UNITED STATES PATENT AND TRADEMARK OFFICE

10/562,056

Office Action Summary	Application No. 10/562,056	Applicant(s) YLI-VAKKURI ET AL.	
	Examiner Erin Snelting	Art Unit 1791

DETAILED ACTION

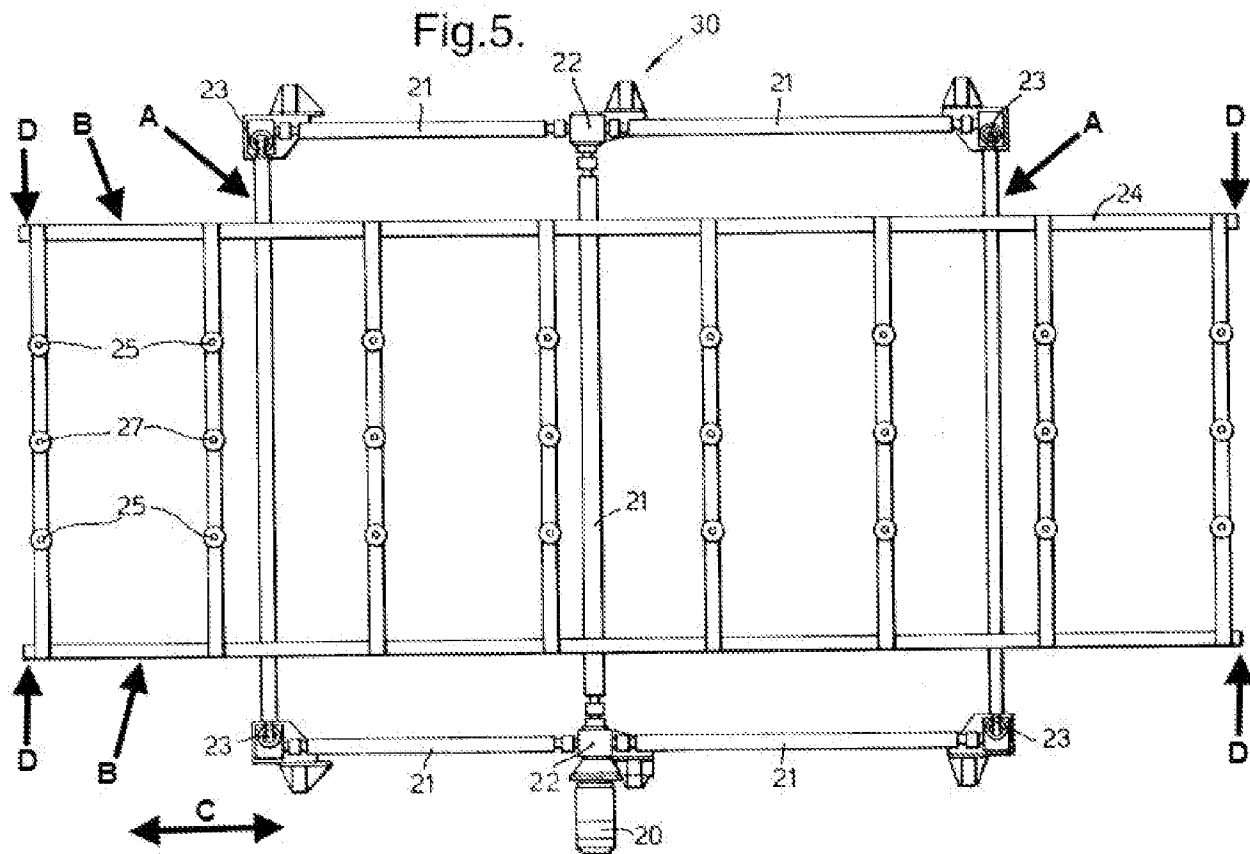
16. Regarding claim 4, Montonen '436 teaches frame, bearer elements, press-bending compartment as described for claim 1 above. Montonen '436 does not teach two elongated girders, which are disposed at a distance from each other underneath the bearer elements and whose ends are formed with flanges extending beyond side walls of the press-bending compartment, and longitudinal beams, each of which is fitted rigidly in a lengthwise direction of the furnace between two successive flanges. In analogous art of glass bending, Bennett '477 teaches (see examiner's references to Fig. 5, inserted below):

- a. two elongated girders (**A**) which are disposed at a distance from each other underneath the bearer elements ("lifting pins 25", column 7, line 53) and whose ends are formed with flanges ("screw jacks 23", column 7, line 52) extending beyond side walls ("furnace side walls 7 (FIG. 3)", column 6, line 31) of the press bending compartment ("A space 5 in the furnace", column 6, lines 29-30, see also Fig. 3)
- b. longitudinal beams (**B**, part of "frame 24", column 7, line 52), each of which is fitted rigidly ("The driveshafts operate lead screws of the screw jacks 23 upon which the frame 24 is mounted", column 7, lines 58-59) in a lengthwise

direction of the furnace (**C** – note that direction **C** is projecting into the plane of Fig. 3, and it is equivalent to direction “G” in Figs. 1, 2a, and 2b) between two successive flanges (**D**)

for the benefit of providing adequate and stable support for the mould carriage during the press-bending process, and also for positioning movement actuators outside of the press-bending compartment to simplify maintenance and so as not to expose the actuators to the heat of the compartment. Note that “flange” is interpreted as a projection formed to give additional strength, stiffness, or supporting area, or to provide a place for the attachment of other objects. It would have been obvious to one of

ordinary skill in the art at the time of the invention to combine the method of Montonen '436 (and Peltonen '645), Yli-Vakkuri '953, and Leponen '440 with the frame of Bennett '477 for the benefit of providing adequate and stable support for the mould carriage during the press-bending process, and also for positioning movement actuators outside of the press-bending compartment to simplify maintenance and so as not to expose the actuators to the heat of the compartment.
